**PRODUCT
SUPPORT
BULLETIN # 356**

6101, 6105, 6101-6 BANDFILE

SUBJECT: 14-46-0975 BANDFILE Head Assembly

14-46-0975 BANDFILE Head Assembly

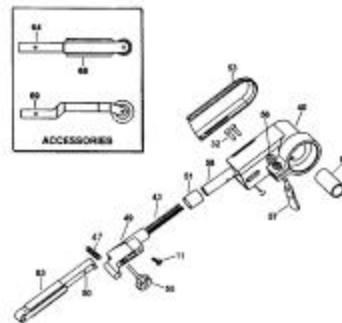
14-46-0975 BANDFILE Head Assembly is **replacing** the 28-50-0250 Housing found on the 6101 and 6105 BandFile.

Please note the Contact Arm Assembly and component parts of the 14-46-0975 BANDFILE Head Assembly are **NOT** interchangeable with original equipment Contact Arm Assemblies and components of the 6101 and 6105 BandFile.

Note! The major visual difference between an original equipment BANDFILE Head Assembly found on 6101 and 6105 BandFiles and the 14-46-0975 BANDFILE Head Assembly, is the one piece collar and clamp screw [thumbscrew] attachment of the 14-46-0975 housing to the spindle hub / gear case of the motor.

After a 14-46-0975 BANDFILE Head Assembly is installed we recommend stamping or etching a 'C' next to the catalog number on the 6101 or 6105 BandFile nameplate. The 'C' will show that the BandFile has been converted. Knowing that a tool has the 14-46-0975 BANDFILE Head Assembly installed will help assure correct replacement parts are ordered/sent should a contact arm, et cetera need replacement at a later date.
